STAFF RECOMMENDATION 1116 Boscobel Street January 18, 2017

Application: New construction – addition and outbuilding
District: Lockeland Springs-East End Neighborhood Conservation Zoning Overlay
Council District: 06
Map and Parcel Number: 08313053300
Applicant: Bonnie Matheson, Owner
Project Lead: Sean Alexander, sean.alexander@nashville.gov

Description of Project: The applicant requests approval to enlarge a non-contributing house with left and right side additions, and to enlarge the front porch. The project also includes a new detached carport at the rear of the lot.

EXTERIOR ELEVATIONS

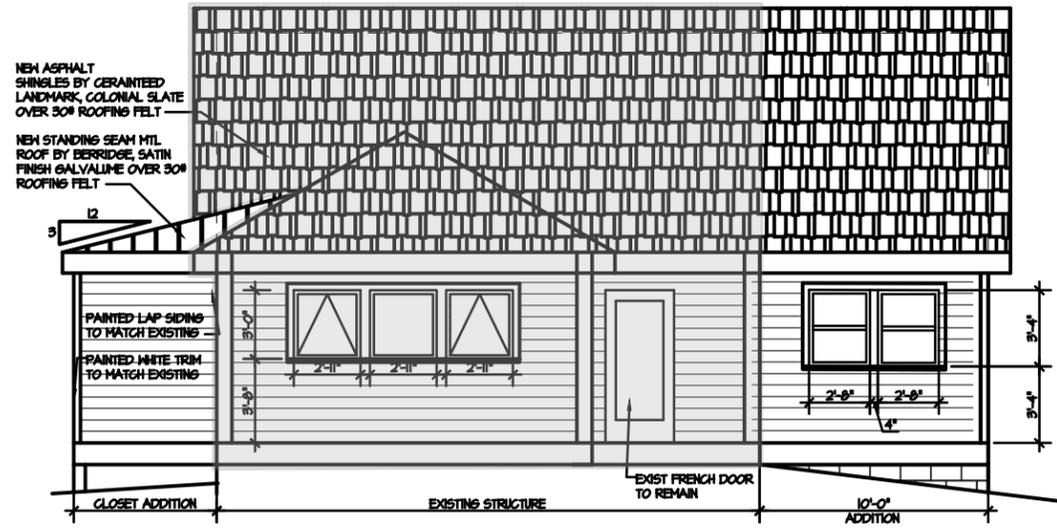
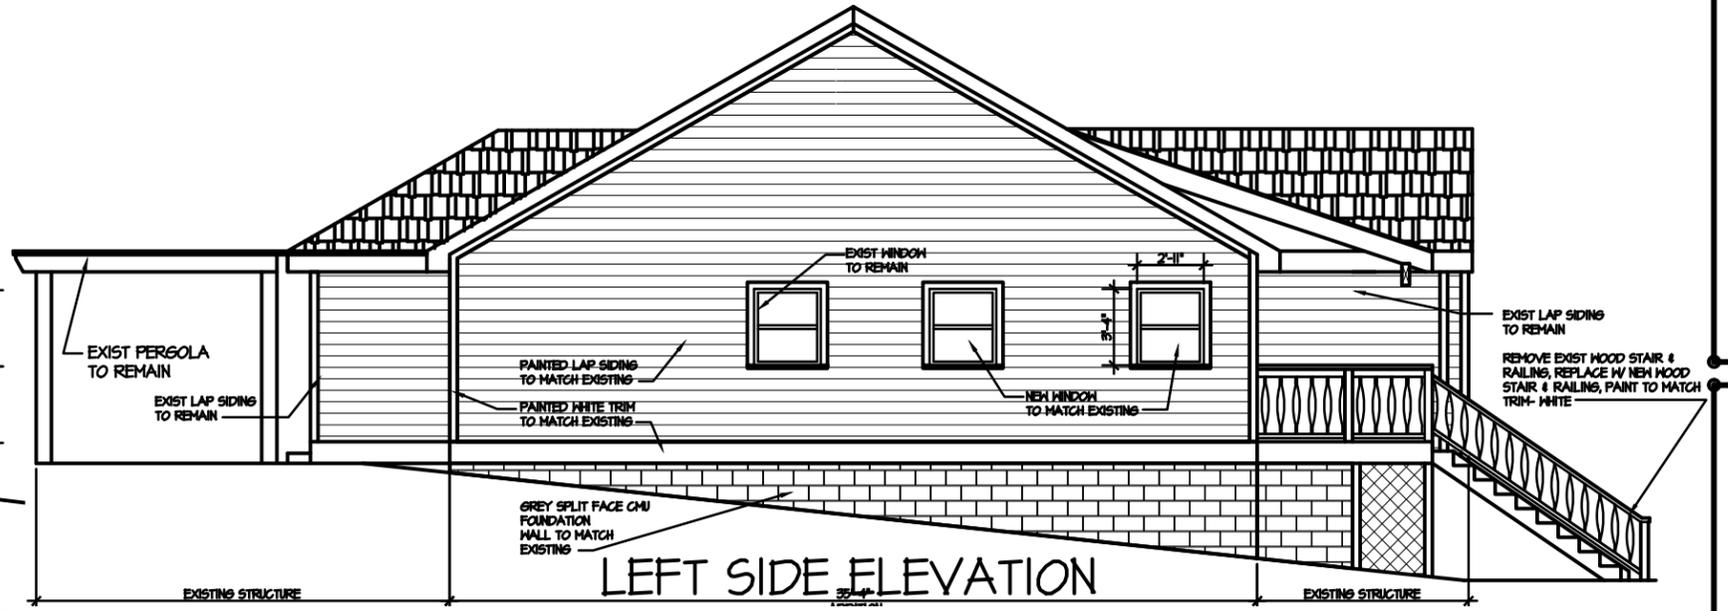
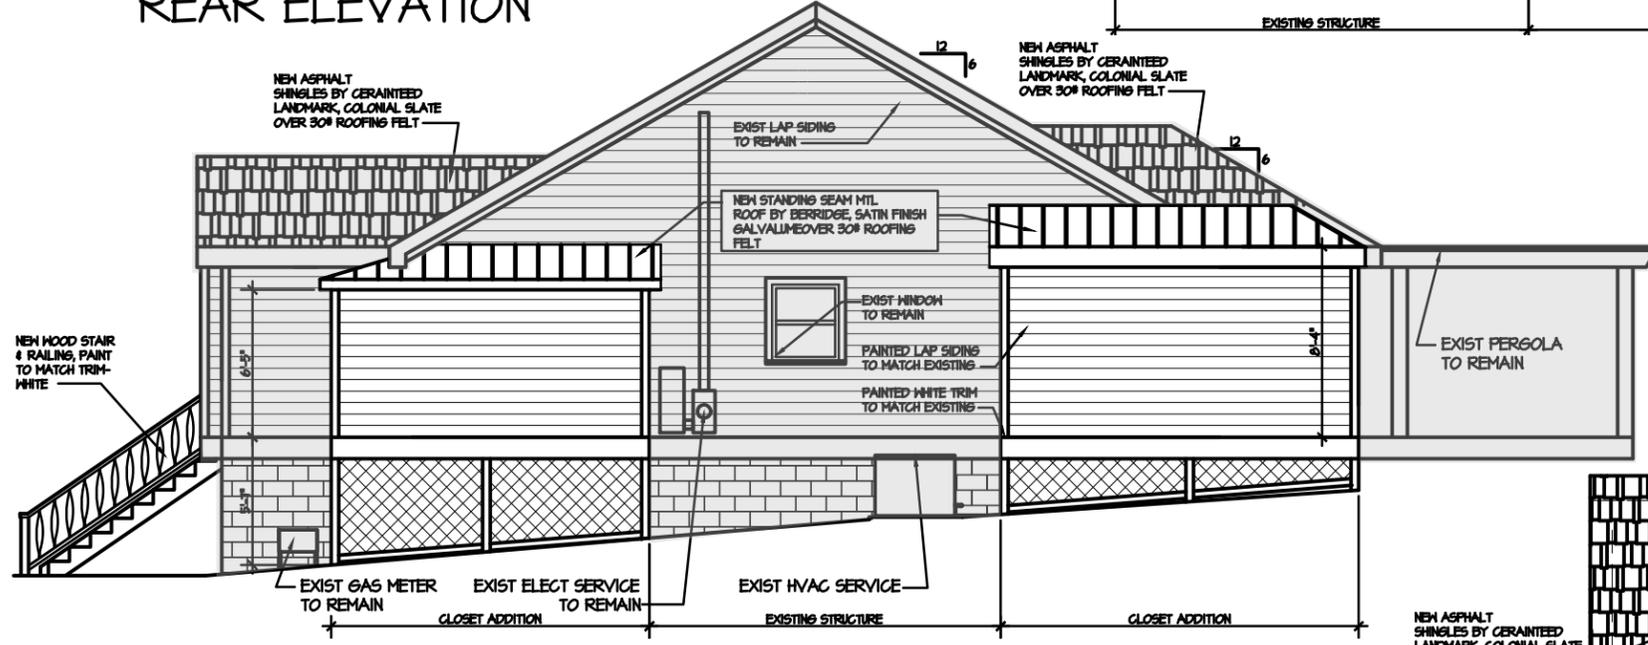
Design: The height and form of the left side addition match the existing building, and the right side additions will be smaller and compatible in appearance. The materials and window proportions will also match the existing building. The additions will be indistinguishable from original parts of the building. Because the existing building is non-contributing, Staff finds that the project meets sections II.B.2.a and II.B.2.e of the design guidelines.

Height & Scale: The left side addition will tie into the front and the eave of the house, and will widen the main component of the building by ten feet (10'). The shape of the building and the roof height and pitch will be matched. Two new bays on the right side will project an additional six feet, three inches (6'-3"). The first of these new bays will be stepped five feet (5') back from the front of the building, and the second bay will be thirty five feet (35') back from the front of the building.

Roof form: The primary roof ridge will be extended ten feet (10') to the left, matching the existing 6:12 pitch. The right-side bay additions will be hipped with a pitch of 3:12. The front porch roof will be extended four feet (4') toward the front, also resulting in a 3:12 pitch. These roof forms are compatible with the roofs of surrounding historic houses. Staff finds that the project meets section II.B.1.e of the design guidelines.

Proportion and Rhythm of Openings: The expanded section of the front wall will have windows matching those on the existing front façade. These windows are twice as tall as they are wide, and are compatible with the proportions of openings on historic buildings. The windows on the left wall and the front of the right addition will match the existing side windows which are double-hung but square. Typically windows on historic buildings are vertically oriented, but Staff finds the proposed windows appropriate because they match windows on the existing building, and because they are on the side and therefore less prominent. There are no large expanses of wall space without a window or door opening. Staff finds the project's proportion and rhythm of openings to meet section II.B.1.g of the design guidelines, but requests to approve the window selections prior to purchase.

Recommendation: Staff recommends approval of the proposed additions and outbuilding at 1116 Boscobel Street, with the conditions that

- The metal roof colors shall be approved prior to construction;
- The front porch railing shall be approved;
- Window selections shall be approved by MHZC Staff.

A-2
 CARPORT
 PLAN
 DATE: 12/21/16

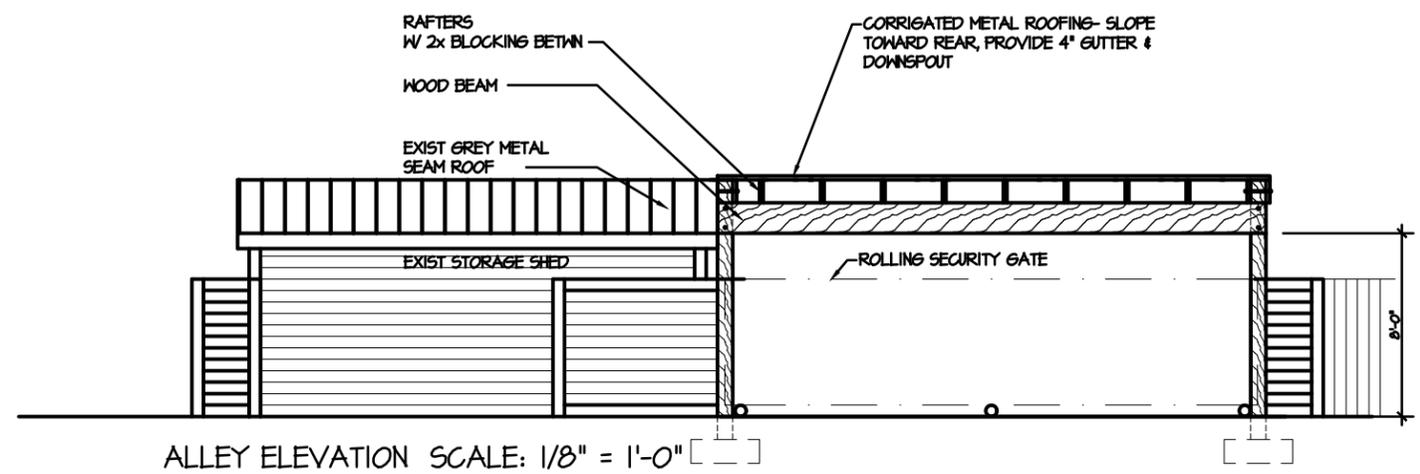
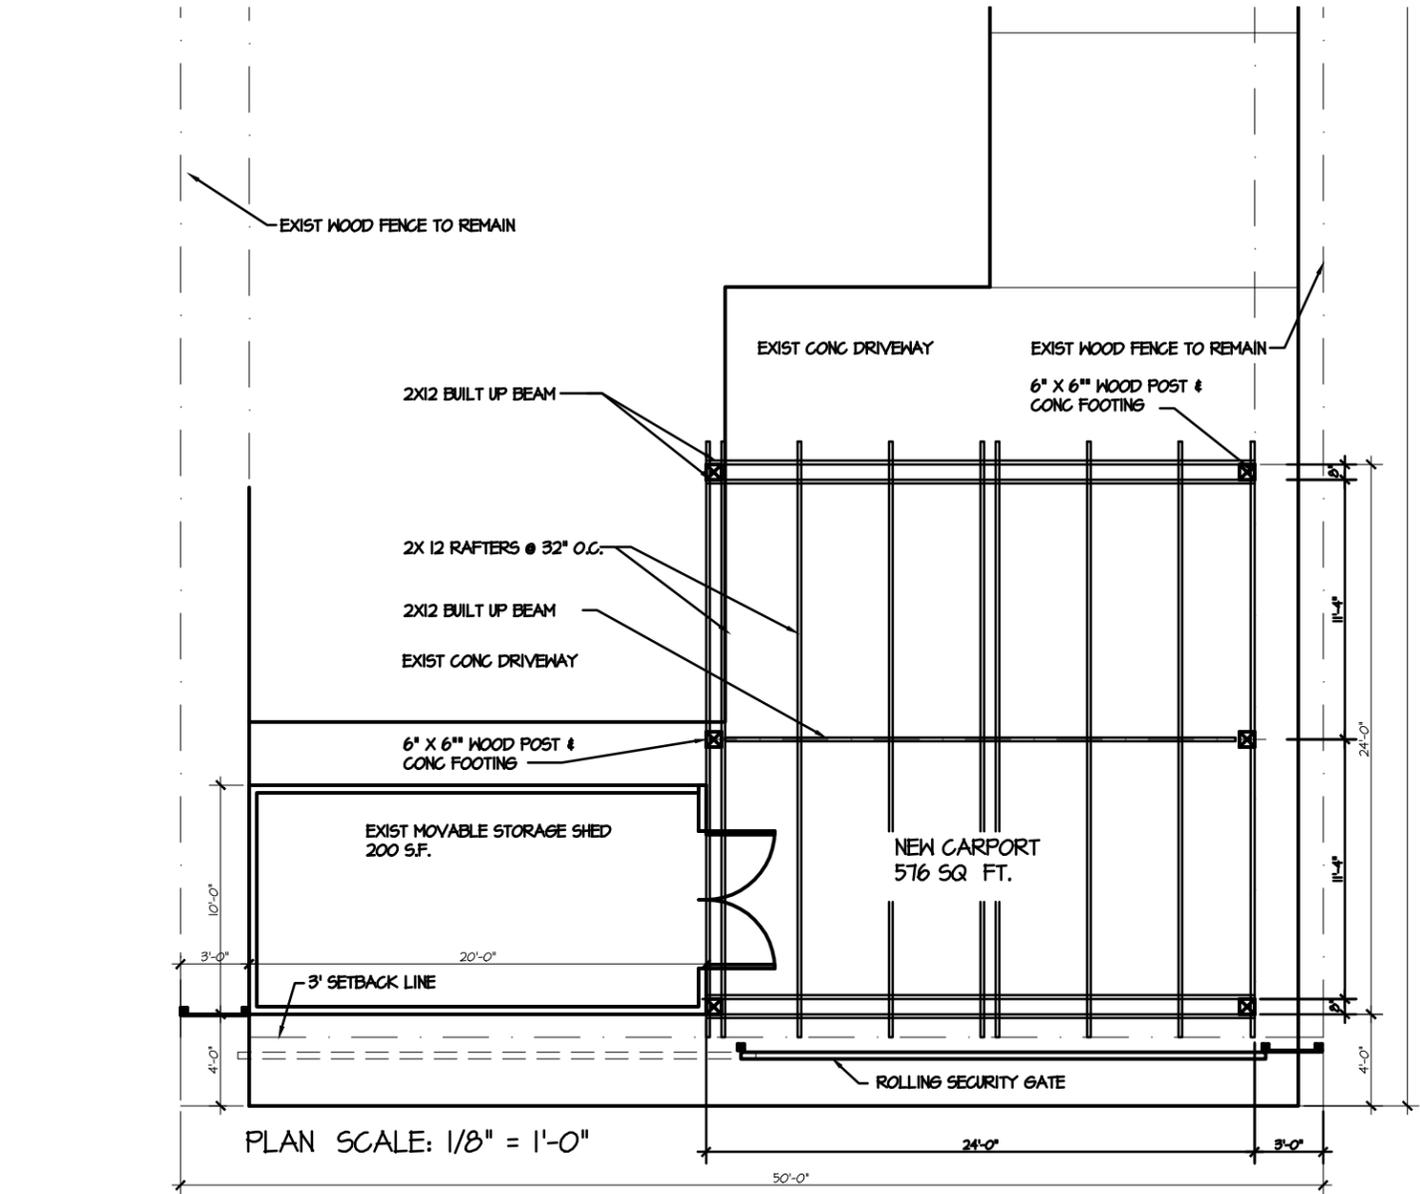
Outbuildings: The proposal also includes a new detached carport at the rear of the lot. There is an existing shed on the lot that is to remain. The shed does not have a permanent foundation. The building will have a footprint area of five hundred, seventy-six square feet (576 sq. ft.), and will be located three feet (3') from the right side and rear property lines. This size and location meet the design guidelines for outbuildings. The carport will be open on all four sides with wooden posts, and will be ten feet (10') tall with a flat roof. Staff asks to approve the roof color prior to construction. The structure meets all the standards and design guidelines, and with the condition that Staff approved the roof color the project will meet section II.B.1.h of the design guidelines.
